Service Bulletin No. 402

MODEL	J4500 Series	TYPE	Field Change Program	SECTION/GROUP	9-Fuel	DATE	Oct. 23, 2013
SUBJECT	DD13 DEF NOZZLE SUPPLY HOSE AND METERING UNIT FITTING						
CONDITIONS

Figure 1.

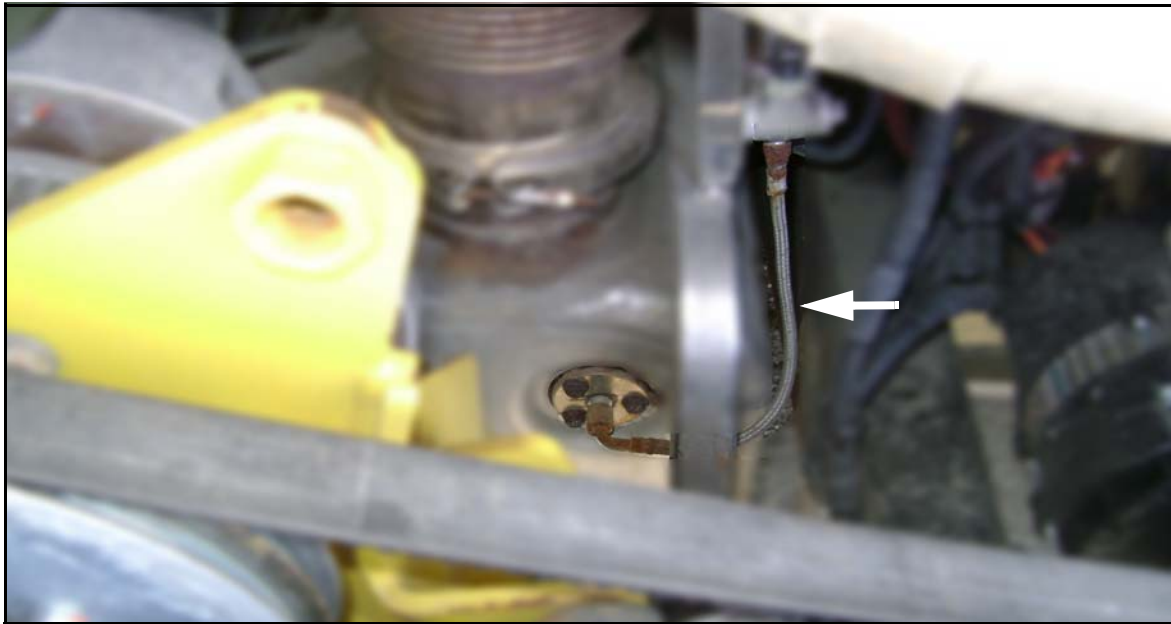
1. Turn the main disconnect switch to the OFF position.
2. Chock both sides of the tires.
3. Open the engine compartment door. Position the ENGINE RUN and ENGINE START switches on the engine remote control box to the OFF position.
4. Locate the stainless steel DEF nozzle supply hose on the selective catalytic reduction exhaust aftertreatment unit (SCR) in the lower, roadside section of the engine compartment (refer to Figure 1).
5. Remove and discard the DEF nozzle supply hose (refer to Figure 1).
6. Orient and install the new DEF nozzle supply hose, p/n 08-20-2409. Torque ends to 11-12 ft.-lbs.

Figure 2.

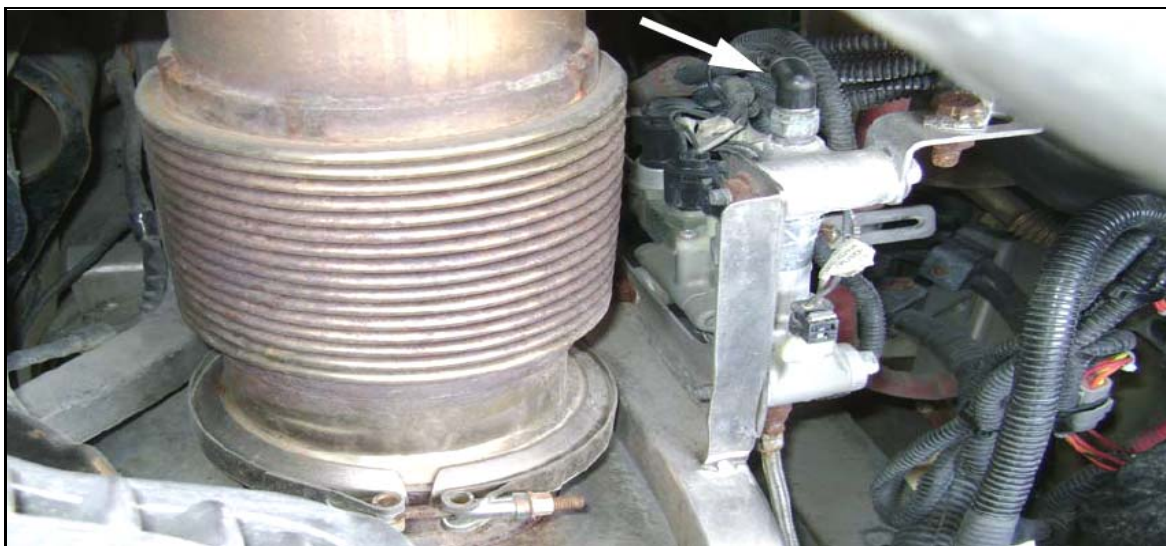
7. Locate the 90 degree fitting on top of the dosing metering unit, directly above the DEF nozzle supply hose installed in Step 6 (refer to Figure 2)
8. Remove and discard the existing 90 degree fitting on top of the dosing metering unit (refer to Figure 2)

Figure 3.

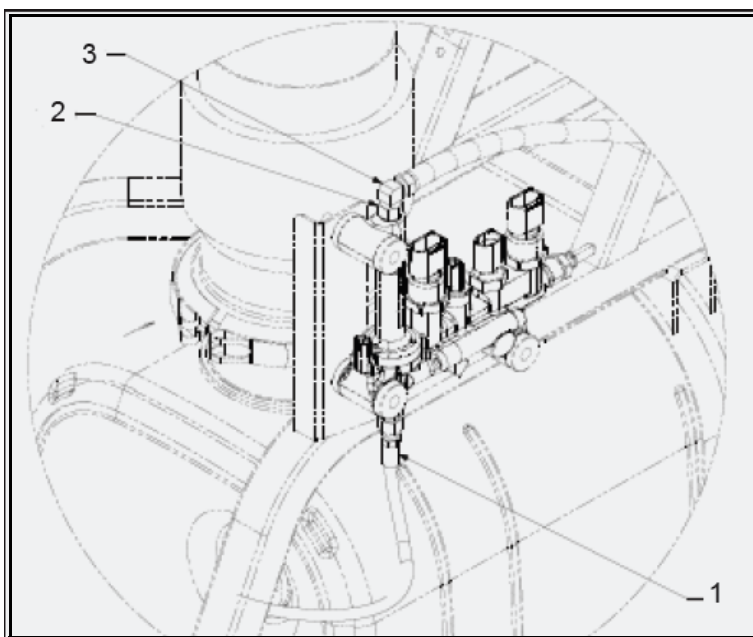
9. Orient and install the adapter, p/n 19-10-3010 (refer to Figure 3). Torque the adapter to 6-9 ft.-lbs.
10. Orient and install the fitting, p/n 19-10-1403. Cut 0.50 inch off the end of the hose. Connect the hose to the fitting. Tighten to secure.
